Access Compliance Report

Public Rights-of-Way

(Curb Ramps)

Intersection ID: 9002	Main Street: BARRINGTON_DR	Cross Street: COVECREEK_DR	Location: S
ADA ID: 3253307C0F10	Ramp Type: PerpDiag	Initial Pass/Fail: Fail	Overall Compliance: No
Severity Score: 13.75			
Codes/Mitigation Info/Possible Solution		Field Measurements/Component Compliance

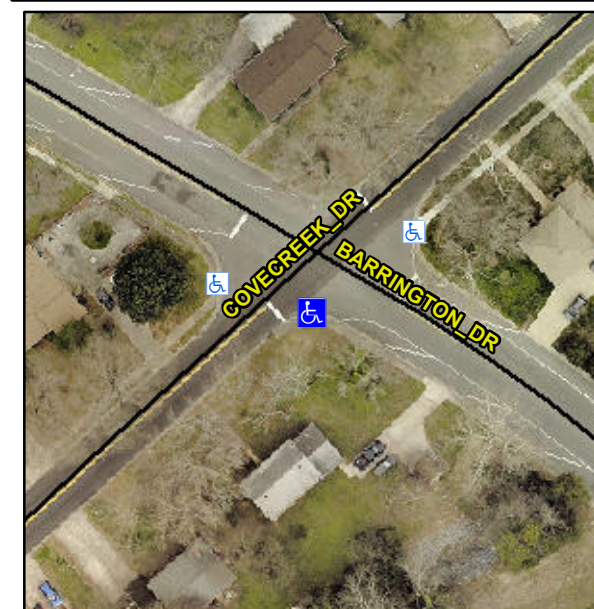
R304.2.2, R304.5.3

Compliance	Description	Data	Compliance	Description	Data
N/A	Ramp Length (in)	47.0	No	Ramp Slope (%)	11.1
Yes	Ramp Width (in)	48.0	No	Ramp XSlope (%)	4.3
N/A	Flare Type LT	N/A	N/A	Flare Type RT	N/A
N/A	Flare Slope LT (%)	N/A	N/A	Flare Slope RT (%)	N/A
N/A	Flare Traversable LT?	N/A	N/A	Flare Traversable RT?	N/A
N/A	Landing Length (in)	N/A	N/A	DWS Provided?	N/A
N/A	Landing Width (in)	N/A	N/A	DWS Contrast?	N/A
N/A	Landing Slope (%)	N/A	N/A	DWS Length (in)	N/A
N/A	Landing X Slope (%)	N/A	N/A	DWS Full Width?	N/A
N/A	Landing Curb? (Y/N)	N/A	N/A	DWS Offset (in)	N/A
N/A	Shared Landing?	N/A			
N/A	Gutter Ponding?	N/A	N/A	Gutter Slope (%)	N/A
N/A	Gutter Lip Ht (in)	N/A	N/A	Gutter X Slope (%)	N/A
N/A	Painted X Walk1?	No	N/A	Painted X Walk2?	No
	X Walk 1 Direction	To NE		X Walk 2 Direction	To NW
N/A	X Walk 1 Width (in)	N/A	N/A	X Walk 2 Width (in)	N/A
	X Walk 1 Slope (%)	2.4		X Walk 2 Slope (%)	4.3
	X Walk 1 X Slope (%)	1.6		X Walk 2 X Slope (%)	2.9

Remove & Replace Curb Ramp With Two New Directional Ramps or Equivalent.
